0	2	4	6	8	10	
PROJECT RYLANDS BUILDING, MANCHESTER						
CLIENT CD9 PROPERTIES (MANCHESTER) LTD						
TITLE COMPARISON PLAN ROOF - NON MATERIAL AMMENDMENT						
SCALE 1:200@A1 1:400@A3					DATE APR 2023	
JOB No 1526		DWG No AL[05]2224			REV *	
ISSUE FOR PLANNING DOCUMENT

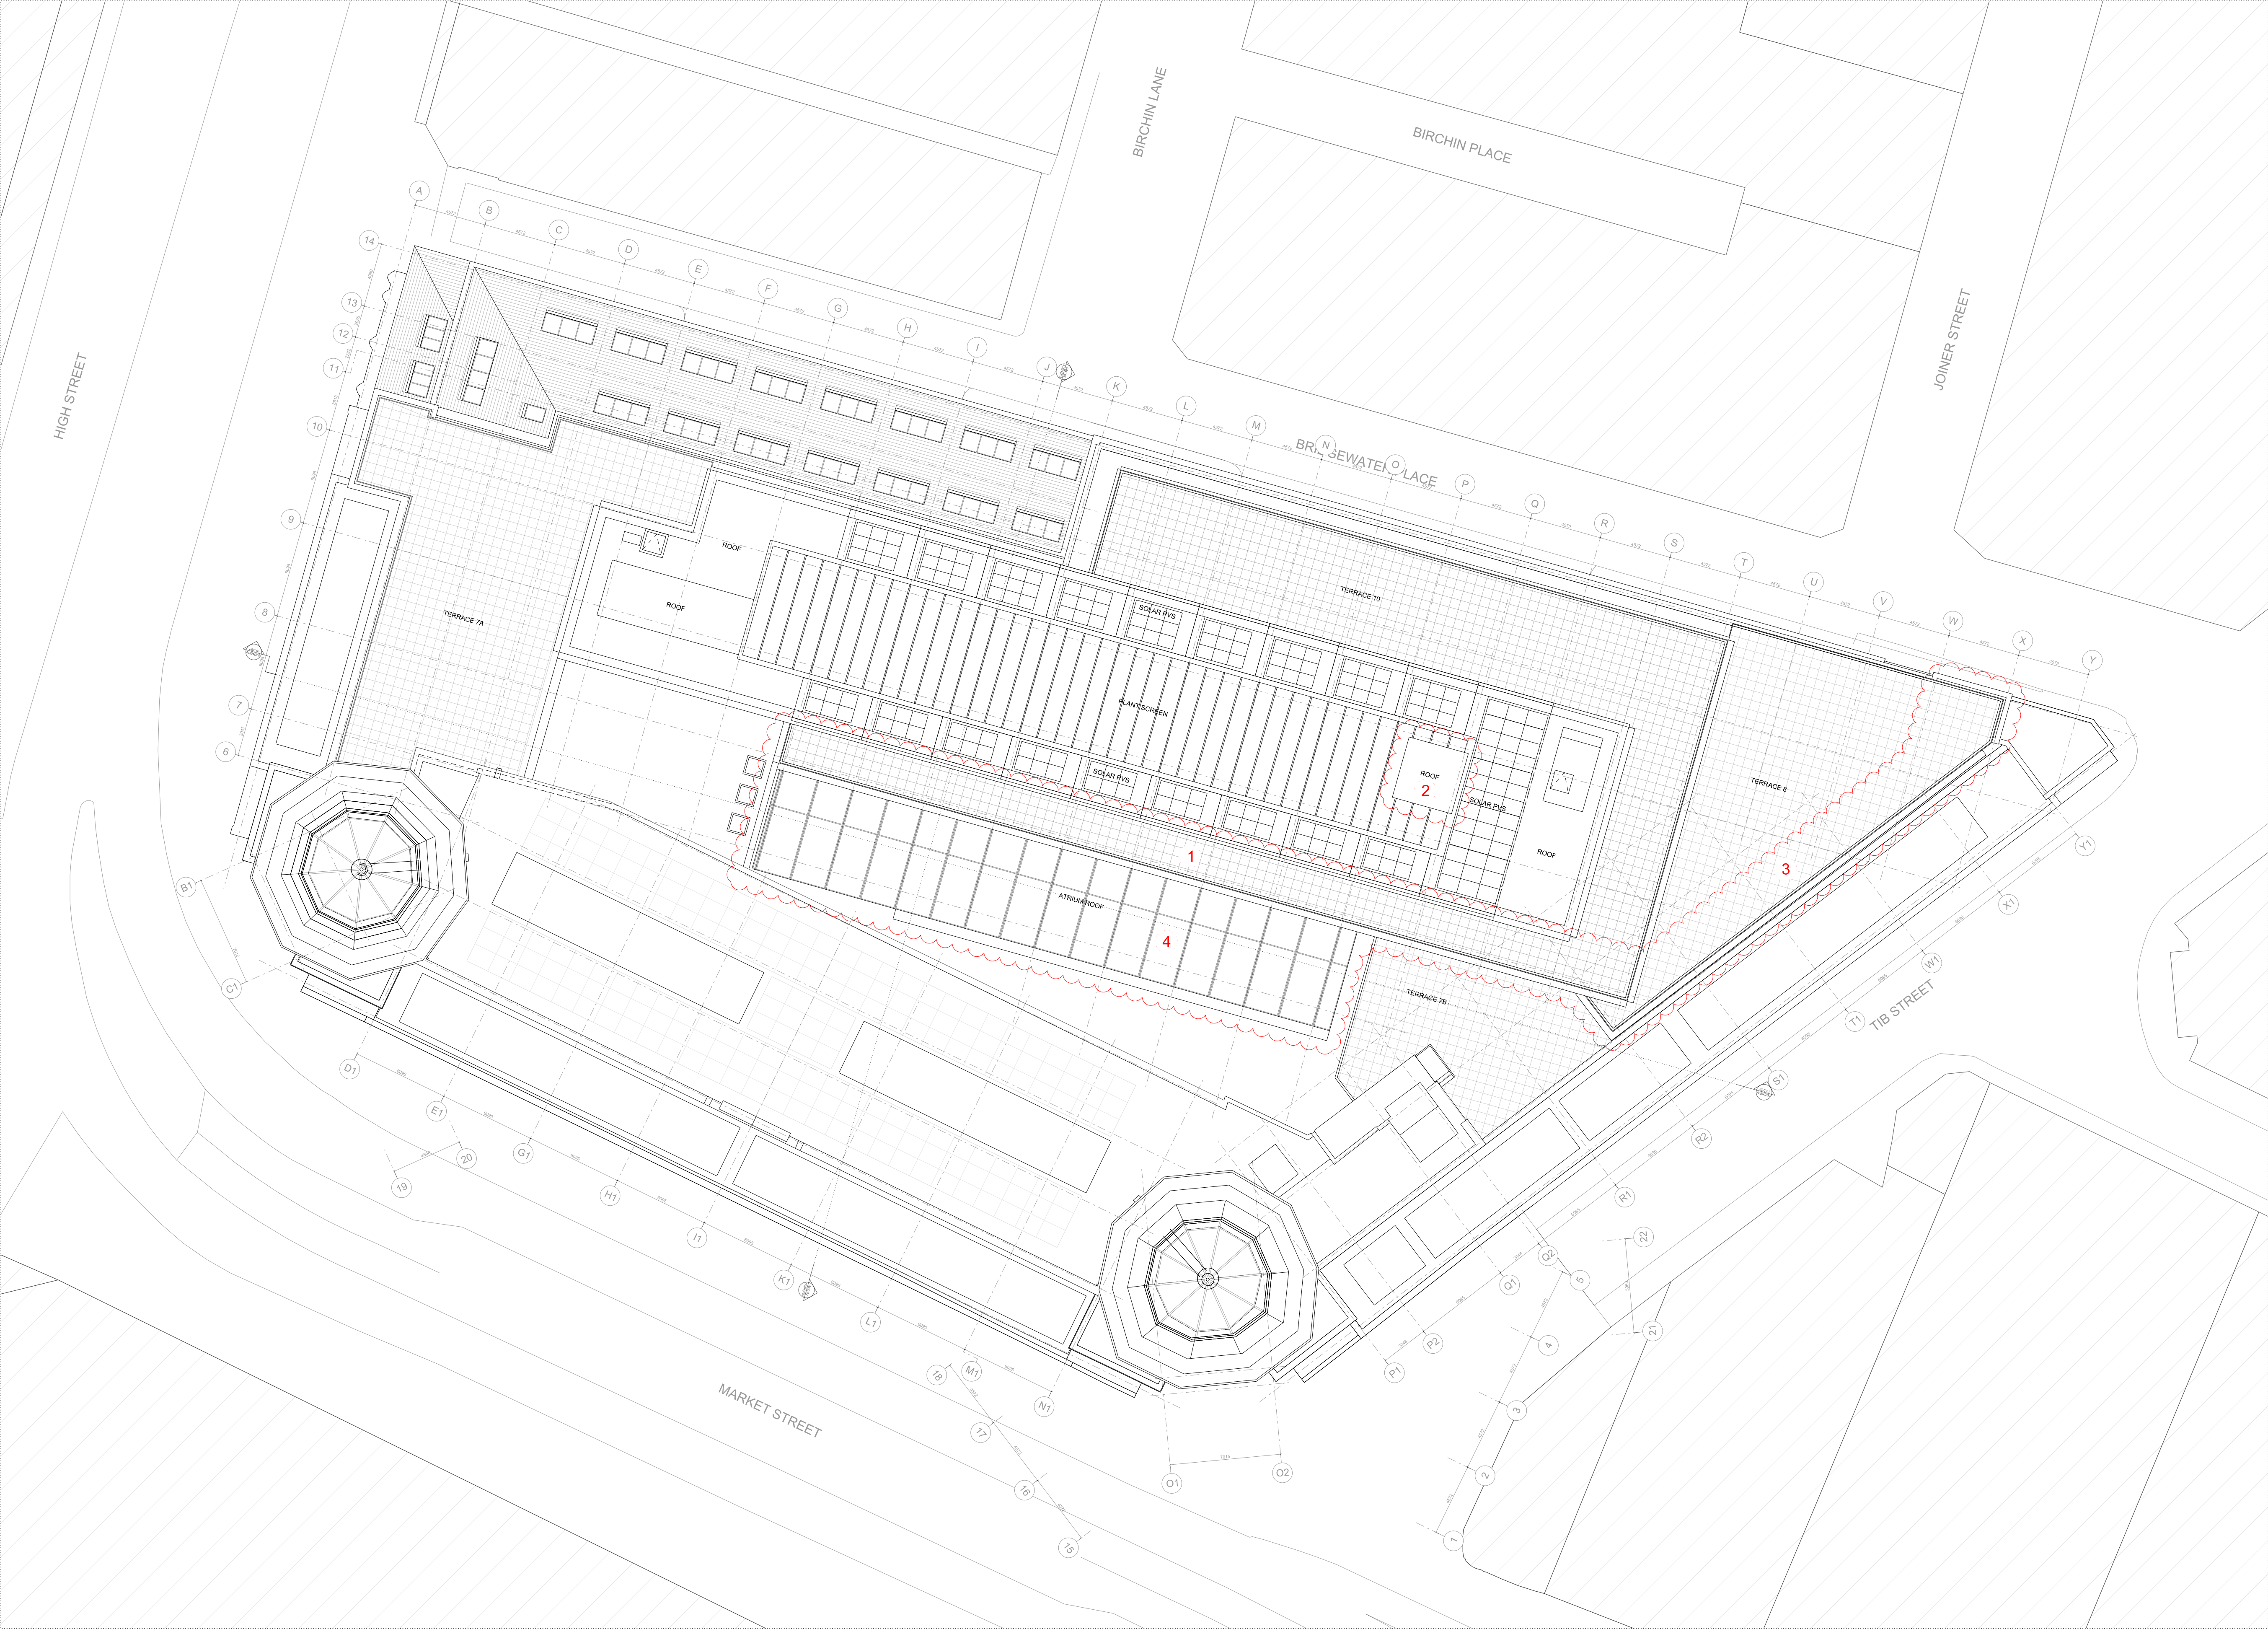
1. Creation of a south facing terrace to respond to change in plan form below and mitigate increase in building height.

2. Roof form amended to stair core 2 to facilitate updated arrangement and additional goods lift to floors below.

3. Extended terrace to respond to change in plan form to floor below.

4. Atrium roof simplified to improve buildability.
